*TOLEDO CITY
PLAN COMMISSION
REPORT*

September 8, 2016

| 1. SPR-33-16 | Major Site Plan Review for new building and parking lot at 3400 Jeep Parkway (rs) |

- Request - Major Site Plan Review for new building and parking lot
- Location - 3400 Jeep Parkway
- Applicant - Overland Industrial Park Two, LLC.
4140 Lockbourne Road
Columbus, OH 43207
- Engineer - Jeff Myers
The Mannik & Smith Group, Inc.
1771 North Dixie Highway
Monroe, MI 48162

MASTER PLAN

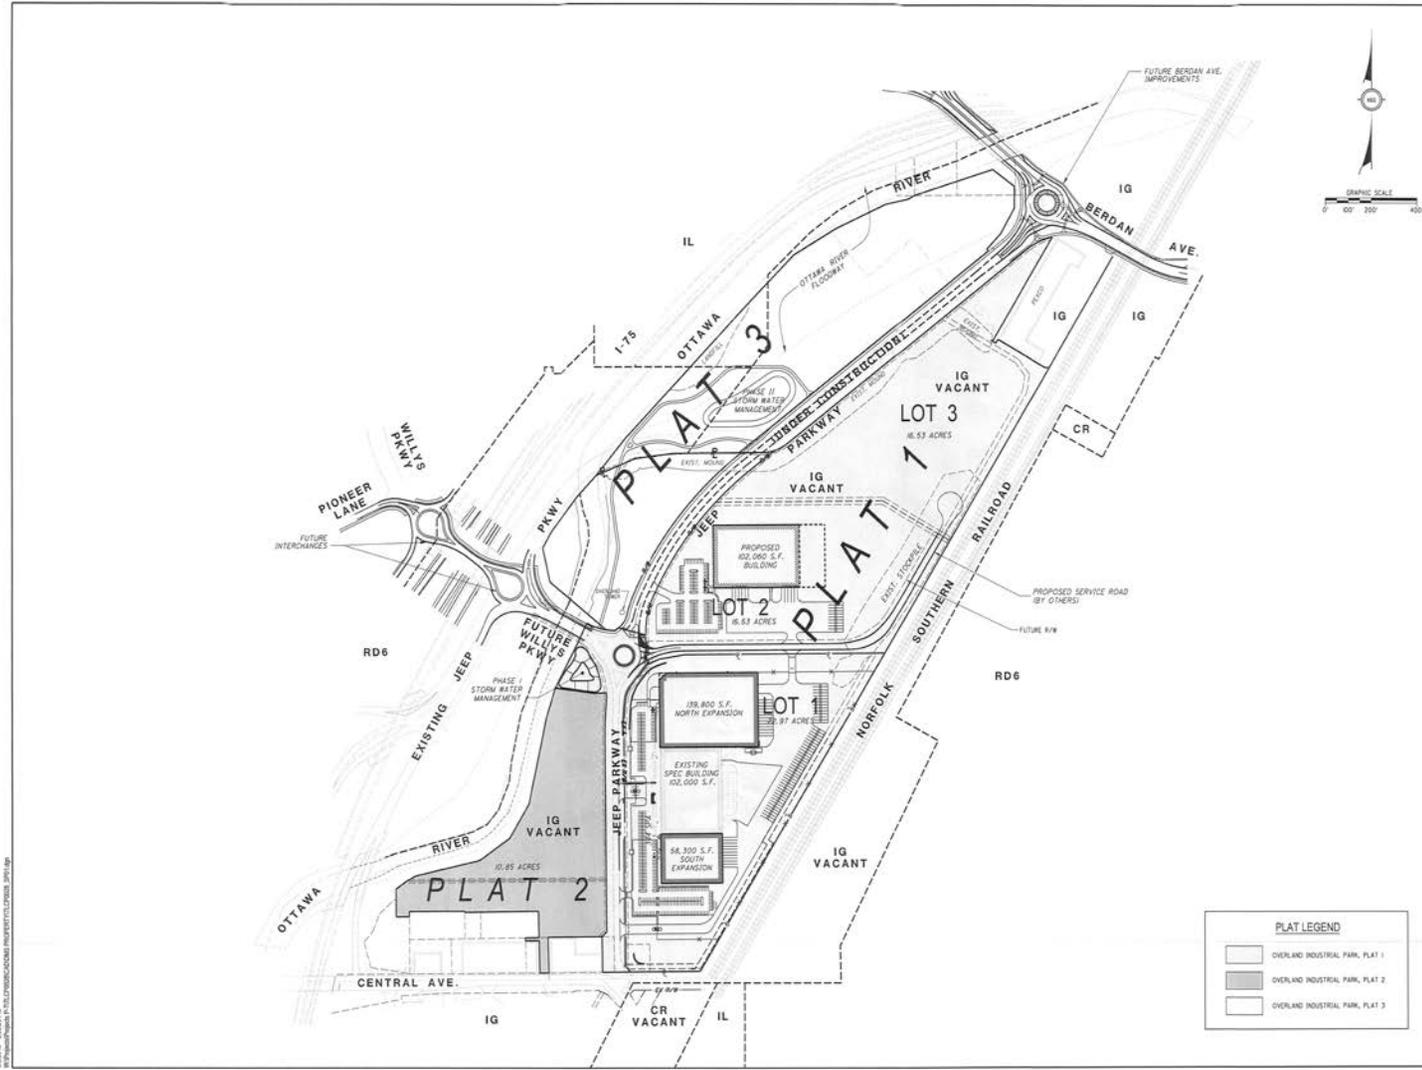
The site plan depicts two access points, one from Jeep Parkway and one from the proposed service drive to the south. Total number of parking spaces provided on site is 167 spaces. Parking requirements for industrial manufacturing and warehouse facilities are calculated cumulatively as listed in TMC§1107.0500 *Off-Street Parking Schedule "C" Additional Industrial Standards*. Calculations using the cumulative square feet of manufacturing floor area indicate a total of 102 parking spaces are required for the facility.

Pursuant to TMC§1107.0302 *Maximums* – an applicant may provide up to 150 percent of the minimum required parking, or equal to 153 spaces. As stated in TMC§1107.1400 *Alternative Access and Parking Plans*, the Director of Planning is authorized to approve alternative parking plans that permit off-street parking spaces in excess of the allowed 150 percent maximum. The parking provided for the proposed expansions exceeds the minimum number of off-street parking spaces. An alternative parking plan shall be submitted to the Director to justify the parking in excess of 150 percent and is listed as a condition of approval. If employee considerations are listed, information shall be provided regarding the potential number of occupants and/or employees per shift.

35. An alternative parking plan shall be submitted to the Director to justify the parking in excess of 150 percent.

LANDSCAPE PLAN

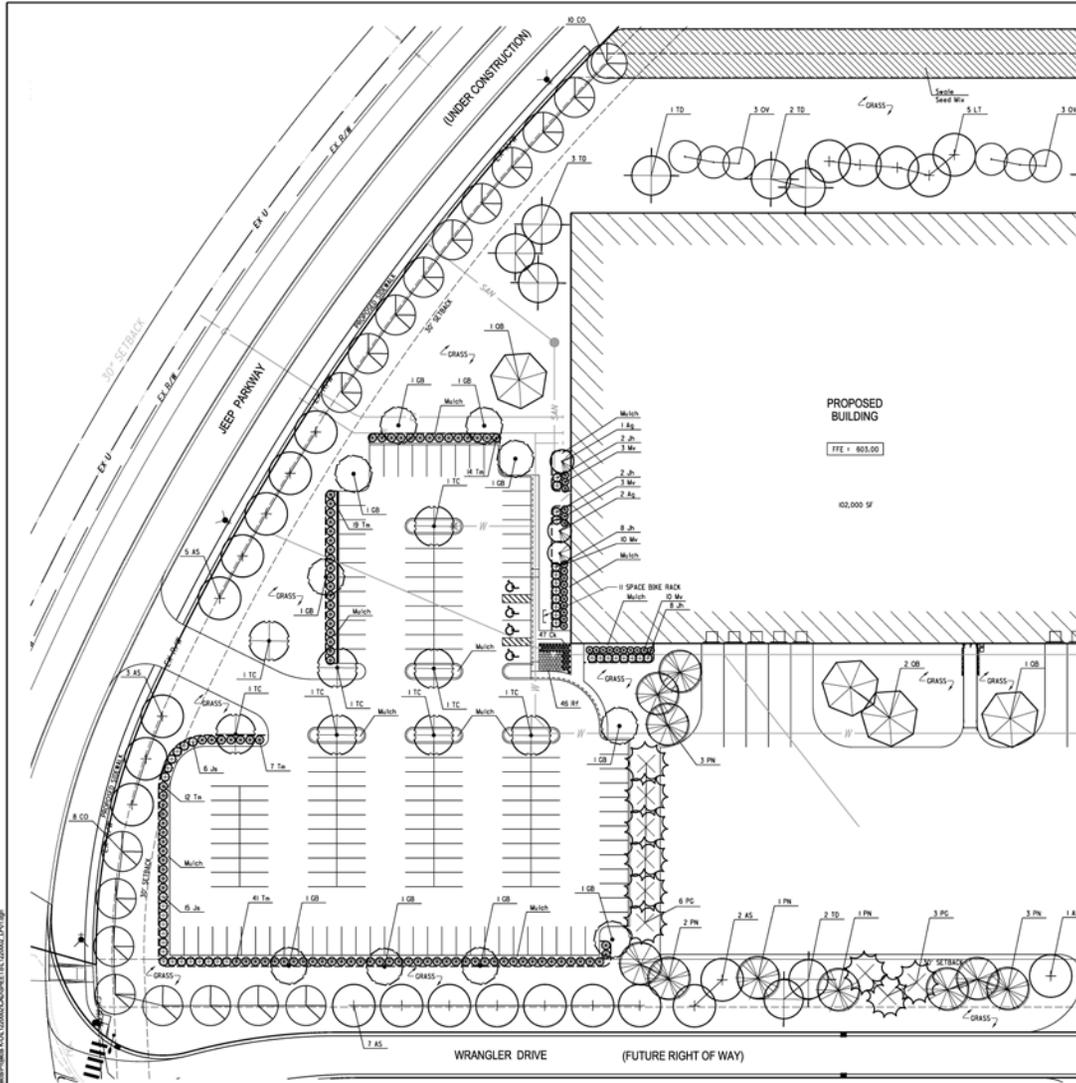
The landscape plan submitted depicts a thirty-foot (30') frontage greenbelt along Jeep Parkway and the service drive with landscaping to screen the proposed parking lot. The landscape plan provided offers sixty-one (61) trees in the required frontage greenbelt and roughly one-hundred fifteen (115) shrubs, most of which sit outside of the greenbelt but screen the parking lot. Additionally, the site plan also indicates that plantings will be installed along the foundation of the buildings and along all perimeter property lines. The landscape plan offers the appropriate amount of trees and shrubs and is acceptable as submitted.

- a. A thirty-foot (30') greenbelt is required along the Jeep Parkway and Wrangler Drive frontages, and shall include a solid evergreen hedge planting and one tree per every 30 feet of frontage; **acceptable as depicted on landscape plan**.

BUILDING ELEVATION

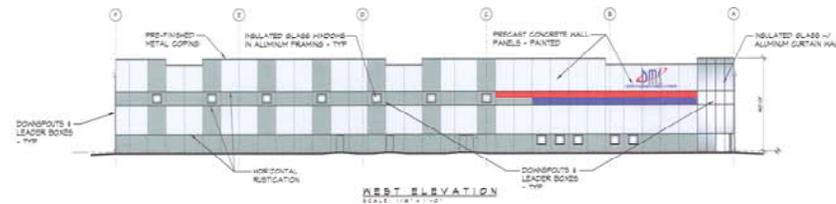
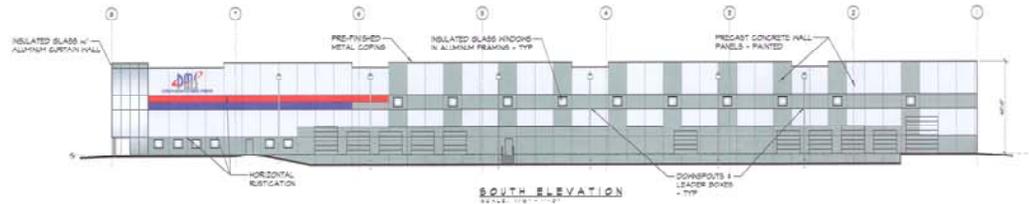
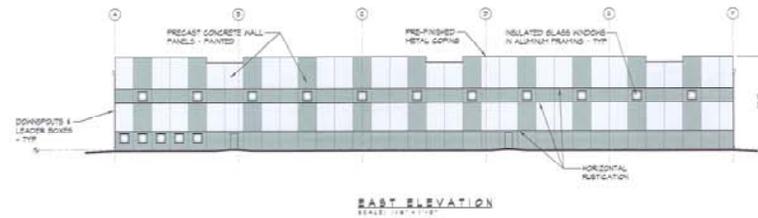
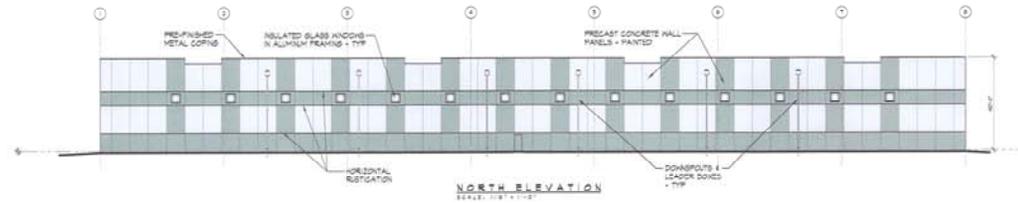
The building elevations indicate the use of precast painted concrete wall panels with insulated glass windows in aluminum framing on all facades. In addition, the applicant will provide an aluminum curtain wall with an insulated glass façade and entry features on the southwest corner of the building. Pursuant to TMC§1109.0400 along major streets, 30% of the building frontage shall not consist of a blank wall and the building shall be painted subtle, neutral or earth tone colors with the exception of the trim and accent areas. The elevations provided meet the criteria required for a new industrial building of this size.
